AI#2 Appendix C

Peat Technical Note

Response to the SEPA Objection (17 April 2020)

3.7 Turbine 15

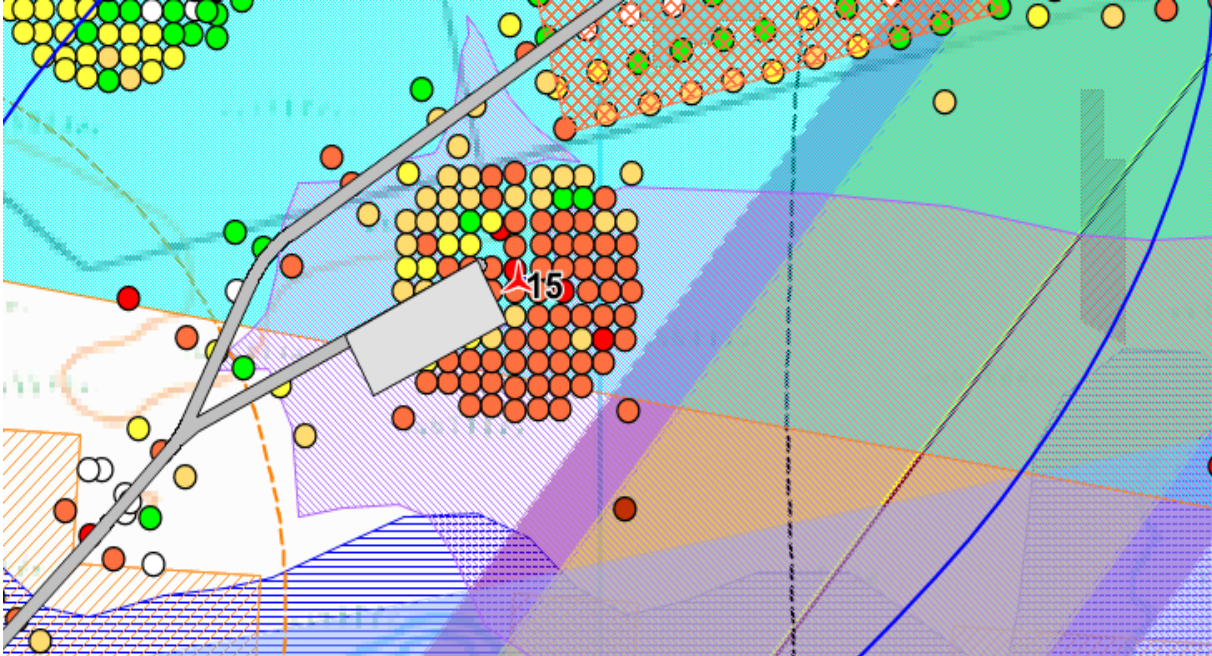
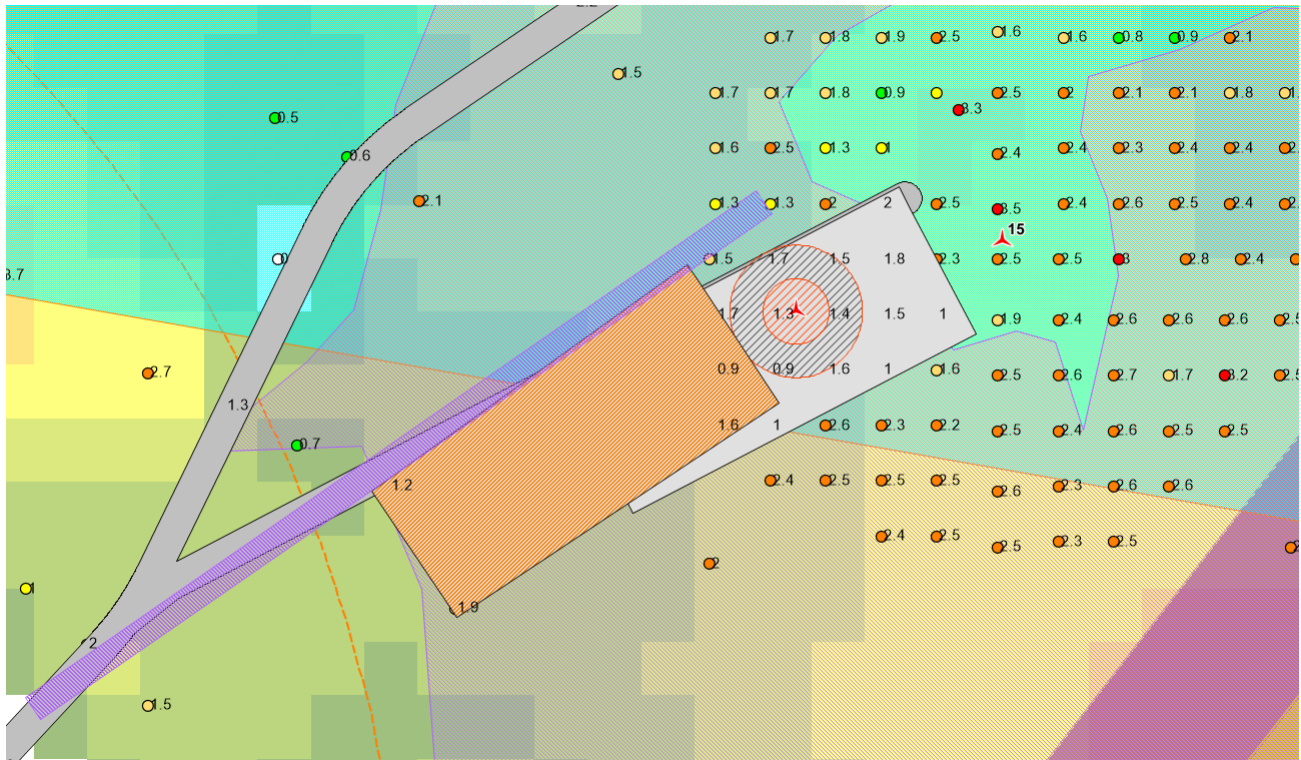
- 3.7.1 **Figure 3.6a** shows the as submitted turbine location, including all the relevant infrastructure constraints as well as the peat depths.
- 3.7.2 SEPA identified that Turbine 15 (T15) is located within peat that is 2-3m deep and should be moved into shallower peat to the south-west where peat depths are 0-2m (green area).
- 3.7.3 This move was reviewed and T15 is located in a highly constrained area with limited opportunity for movement. Notwithstanding these constraints, there is some limited scope to move the turbine south west by approximately 10-20m, which would reduce effects on peat.

- 3.7.4 **Figure 3.6b** shows the proposed slightly amended location of T15. This moves T15 from 2.5m deep peat to 1.3m deep peat, and moves the crane hard stand back towards the south west slighting, towards shallower peat.

- 3.7.5 Before reaching this conclusion, a number of other locations were identified (including a move south of the as submitted turbine location, but north of the now proposed location). Moving the turbine south west would bring the turbine further away from the diver corridor, which would be of benefit to ornithology, however it would also bring the area of hard standing closer to protected species, located to the south west. The compromise is a moved slightly south west but without encroachment on to the protected species buffers.

- 3.7.6 In relocating the turbine, crane pad and road section here, a saving of 754m³ of peat (approximately 30%) could be achieved when compared to the as submitted scheme.

3.8 Turbine 18

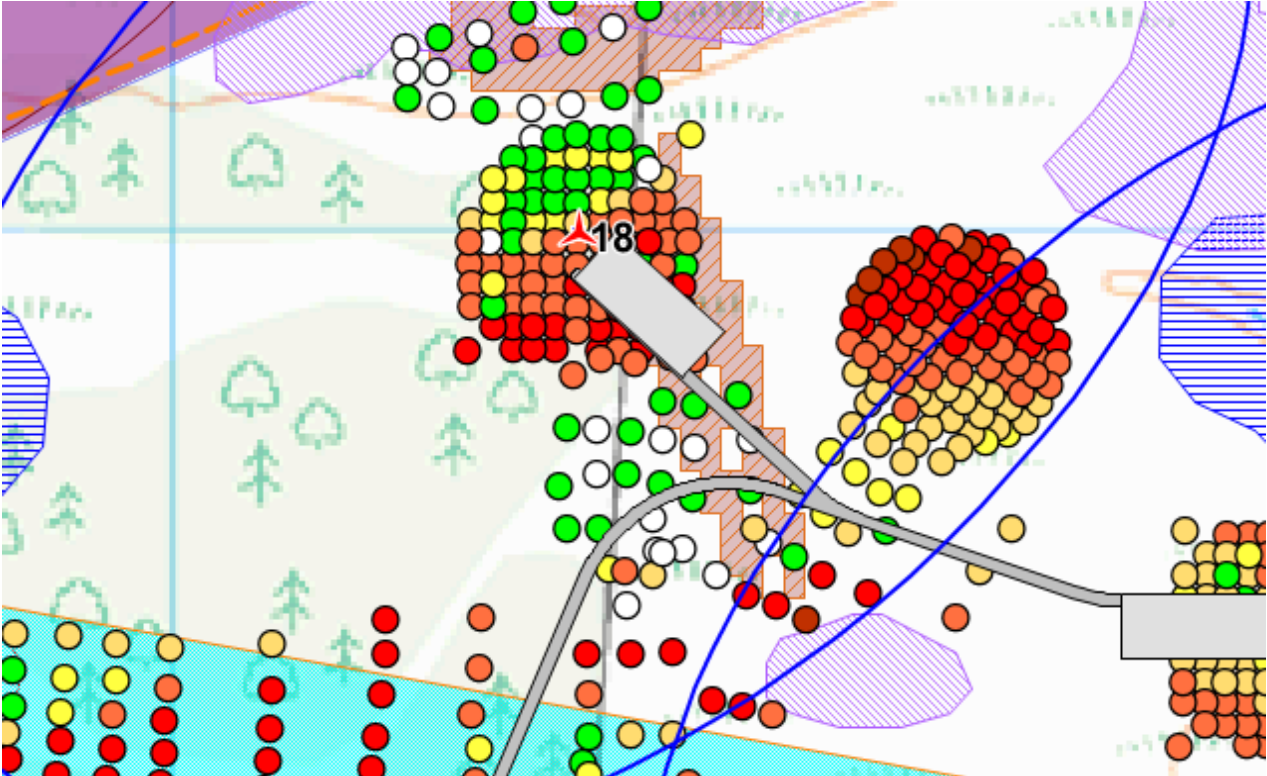
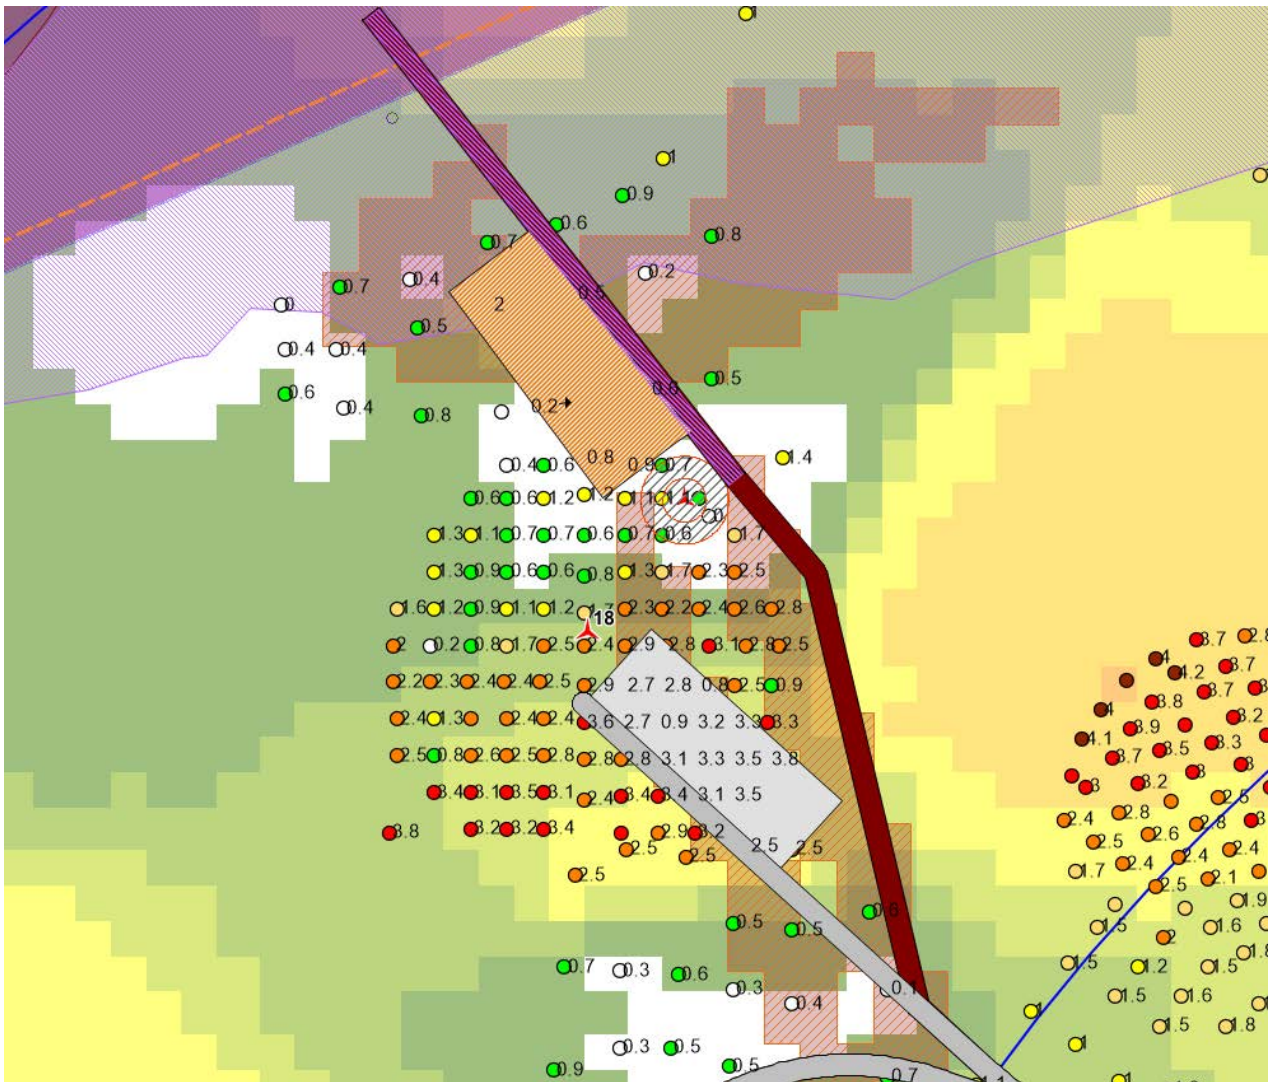
- 3.8.2 SEPA identified that T18 is located within peat that is greater than 4m deep and should be moved into shallower peat directly to the south where peat depths are 0-1m (white and green area along the curve of the access track). Alternatively, the crane pad could be moved onto the shallower peat on the other side of the turbine.

- 3.8.3 This move was reviewed, and peat depths located approximately 6 – 10m to the north are below 2m and in some places, depths are below 1m. There may be scope to move T18 to the north east to this area of shallower peat and move the hard standing to the north east slightly. Alternatively, the pad could orientate 90 degrees and change the access track across the area of deeper peat. However, any movement further south would mean the turbines wake would severely encroach on the wake buffer of T17.

3.8.5 As set out above, before reaching this conclusion, a number of other locations were identified and dismissed as they would result in no saving of peat, or impact on wake separation and constraints. For example, installing the crane pad on the south east side of the track was considered, however it was calculated that the proposed location shown in **Figure 3.7b** would create the most savings in terms of peat disturbance.

3.8.6 In relocating the turbine crane pad and road section here, a saving of 2,722.2m³ of peat (approximately 73%) could be achieved when compared to the as submitted scheme.

3.9 Turbine 19

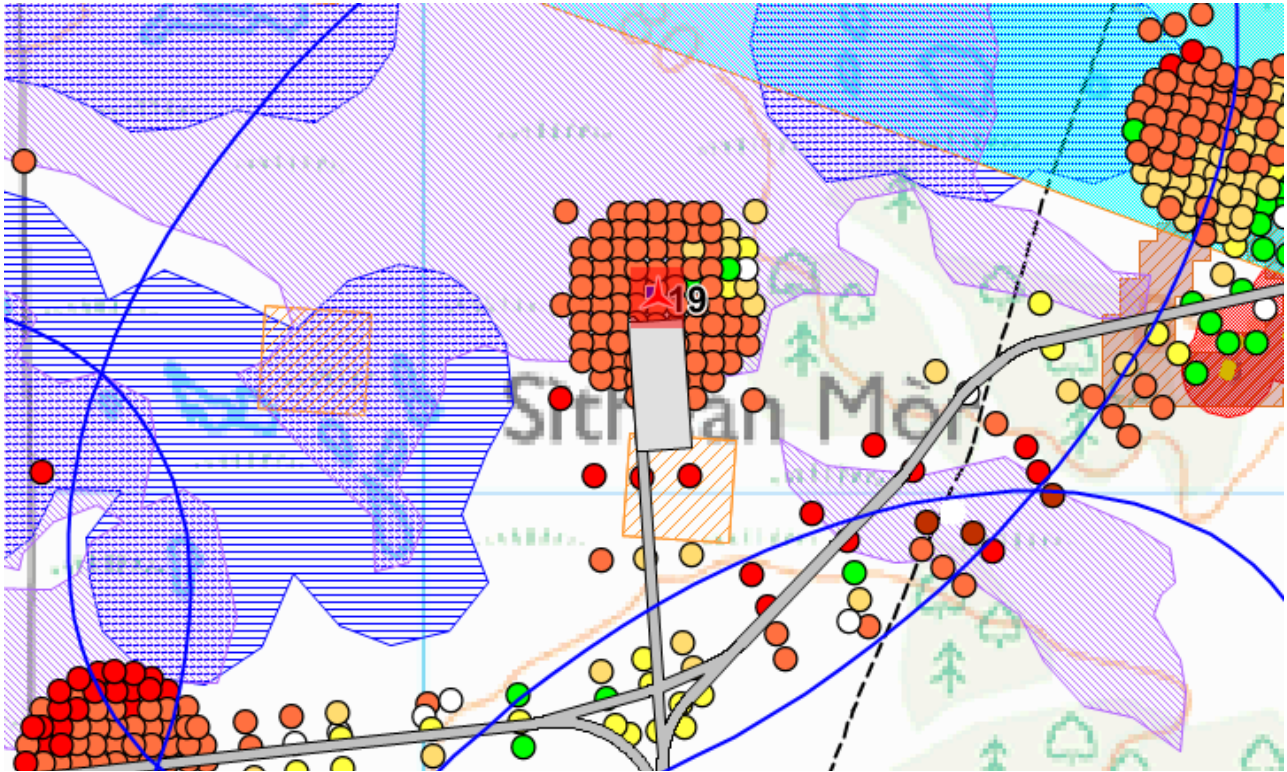
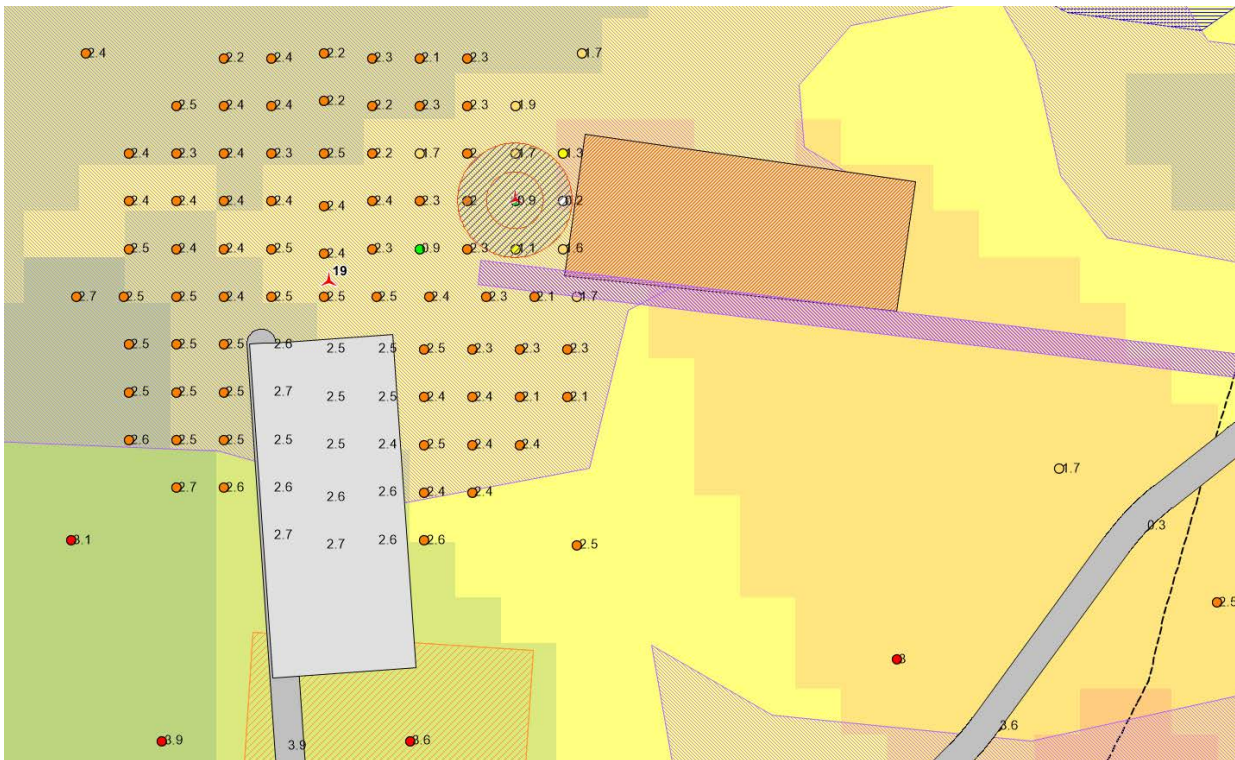
- 3.9.1 **Figure 3.8a** shows the as submitted turbine location, including all the relevant infrastructure constraints as well as the peat depths.
- 3.9.2 SEPA identified that Turbine 19 (T19) is located within peat that is greater than 4m deep and should be moved into shallower peat directly to the south, or elsewhere where peat depths are 0.5-2m (green area just north of junction with main access track).
- 3.9.3 This move was reviewed, and the turbine and crane pad are sited on peat that is actually 2.5m and directly south there is deep peat around 3.6m in a number of locations and area of Pluvial Flood Hazard, moving to the south would majorly impact on T16 wake separation. There is an area of shallower peat to the north east approximately 40 - 50m.

3.9.4 **Figure 3.8b** shows the proposed amended location of T19, crane pad and road section.

3.9.5 As set out above, before reaching this conclusion, a number of other locations were identified, and dismissed as they would result in no saving of peat, or impact on wake separation and constraints. The proposed location of the turbine and track would also result in a simplification of the track junction to the south of the turbine location.

3.9.6 In relocating the turbine crane pad and road section here, a saving of 1,612m³ of peat (approximately 47%) could be achieved when compared to the as submitted scheme.

3.10 Turbine 26

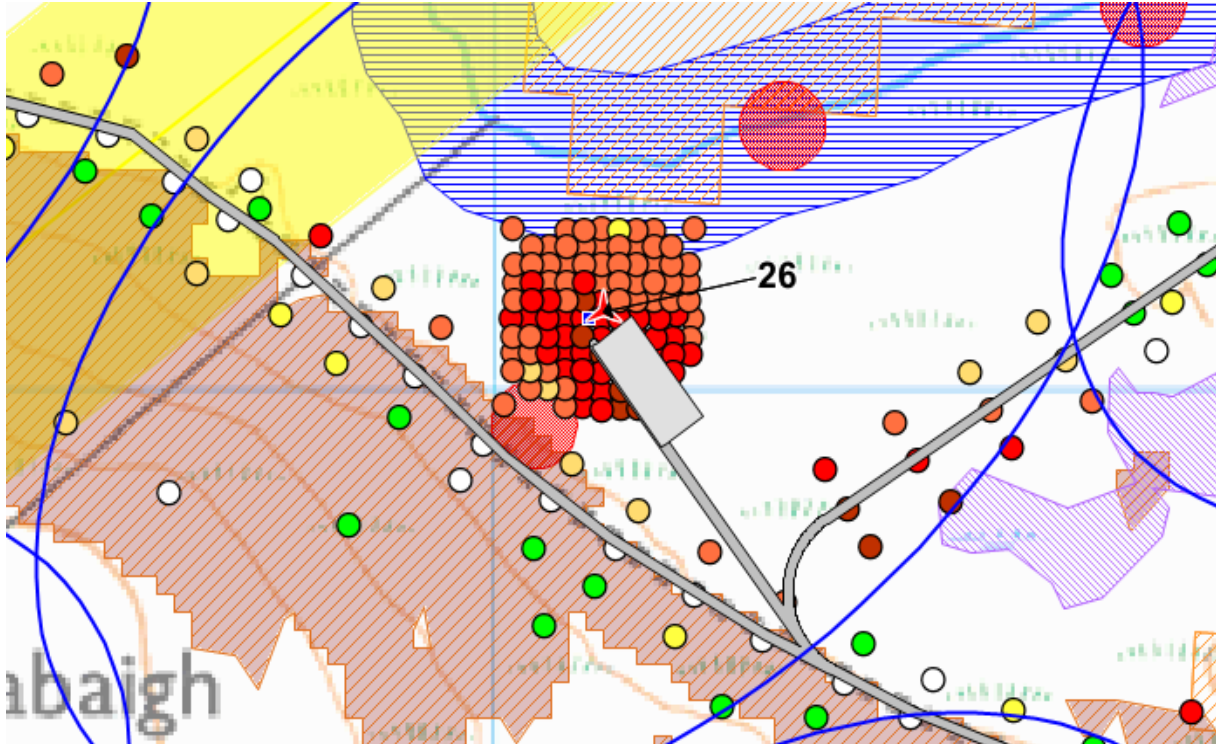
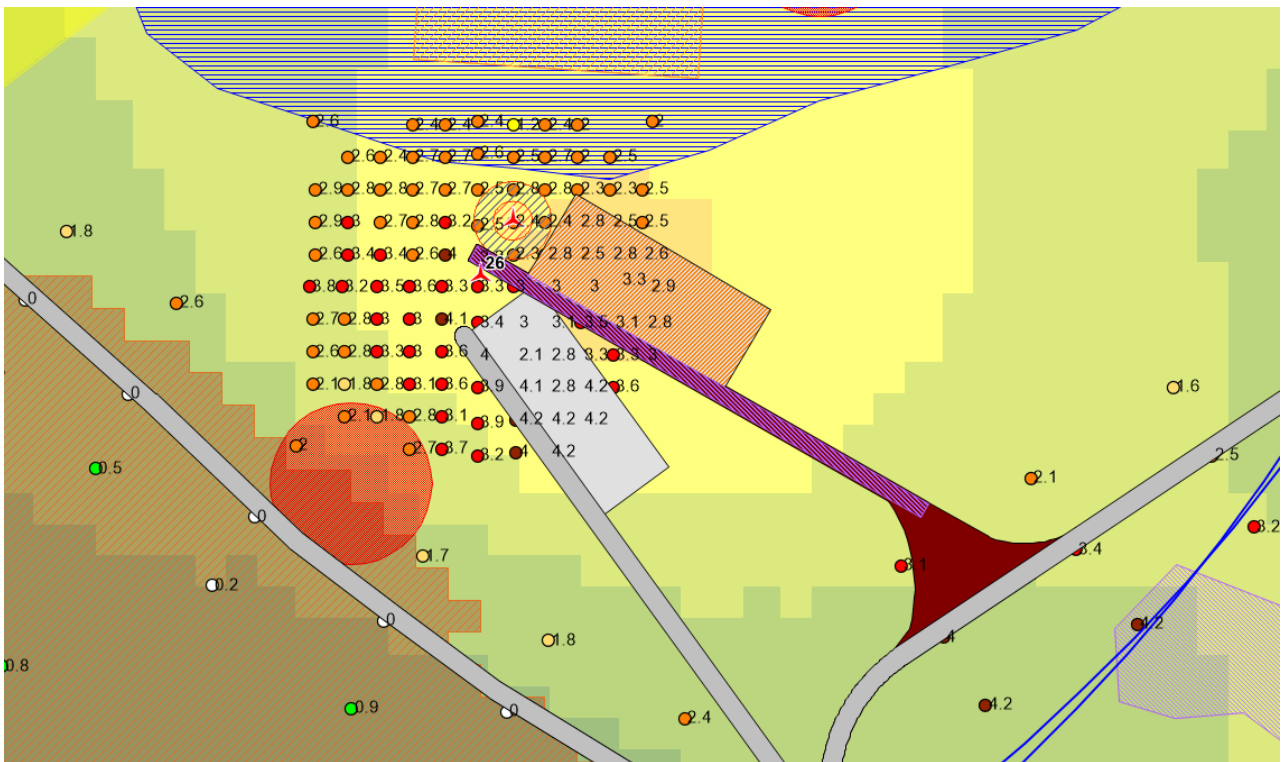
- 3.10.1 **Figure 3.9a** shows the as submitted Turbine 26 (T26) location, including all the relevant infrastructure constraints as well as the peat depths.
- 3.10.2 SEPA identified that T26 is located within peat that is greater than 4m deep and should be moved into shallower peat. There are shallower peat areas along the access track directly south (identified in light green as individual probing point depths of 1-2m) but additional peat probing may be required in this area.
- 3.10.3 This move was reviewed and moving T26 south will impact on the wake from T23 and T24. There is an area of peat to the north east that is slightly shallower (by approximately half a meter) and it is possible to move T26 towards this area, however this would be limited by the wake from T27.

3.10.4 **Figure 3.9b** shows the proposed slightly amended location of T26.

3.10.6 Relocating T26 would result in a small change to the layout of the access track to the south. This is because a straight section of road approximately 160m is required for crane jib assembly.

3.10.7 In relocating the turbine, crane pad and road section here, a saving of 655m³ of peat (approximately 15%) could be achieved when compared to the as submitted scheme .

Figure 3.10a As Submitted Turbine Location and infrastructure

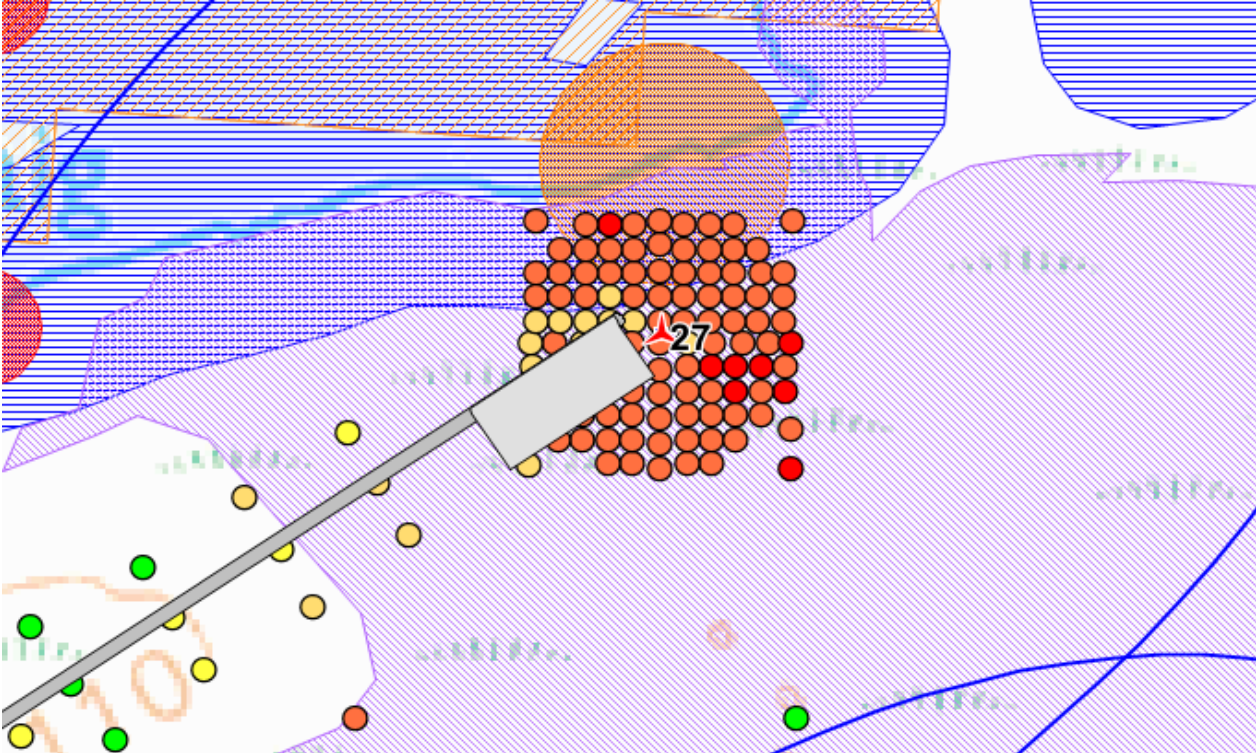
- 3.11.1 **Figure 3.10a** shows the as submitted Turbine 27 (T27) location, including all the relevant infrastructure constraints as well as the peat depths.
- 3.11.2 SEPA identified that T27 is located within peat that is 2-3m deep and should be moved into shallower peat south-west directly along the access track to where probing depths indicate 0-0.5m (white and dark green areas).
- 3.11.3 This move was reviewed, and T27 is currently in peat that is close to 2m, if T26 microsited north east and T27 microsited south west they would have a major impact on each other's wake separation.
- 3.11.4 However, there is some scope to move T27 slightly to the north west by approximately 10m, putting T27 into areas of peat below 2m, and slightly moving the hardstanding may further reduce peat effects slightly.
